MAMUN KNITWEAR LTD.

29 May 2023

Building 11 (Mamun Knit): is a seven storied (G+6) reinforced concrete (RC) building.

**“Detailed Engineering Assessment Report” needs to
be updated**

Brick chip on 6th floor

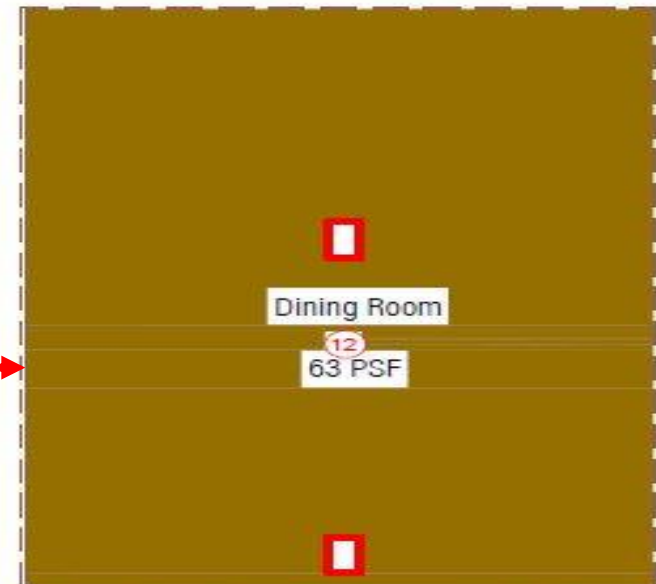
As per “Detailed Engineering Assessment Report” four concrete cores were taken from above fifth floor and brick chip was found in column at sixth floor. During inspection, neither any core sample nor test report was available on site for those cores. Building engineer is required to investigate the issue and clarify accordingly. However, consider all test results in the DEA report.

Storage on 6th floor

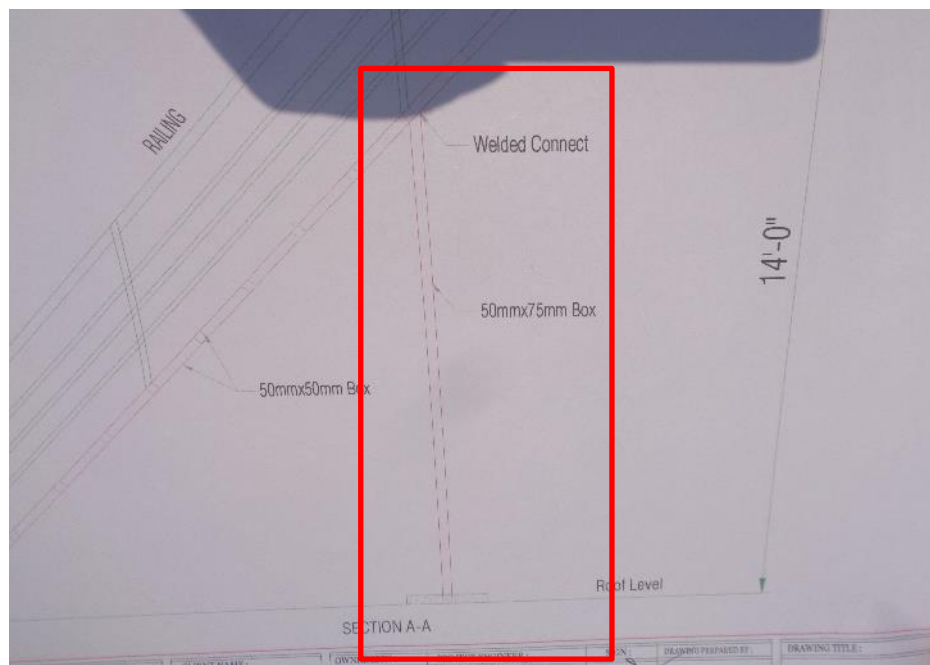
Storage on 6th floor was found instead of dining. As per BNBC-Part 6, live load for light storage areas is required to be considered minimum 6 kPa. However, the building engineer is required to revise the load plan as per BNBC requirement and check the design accordingly.
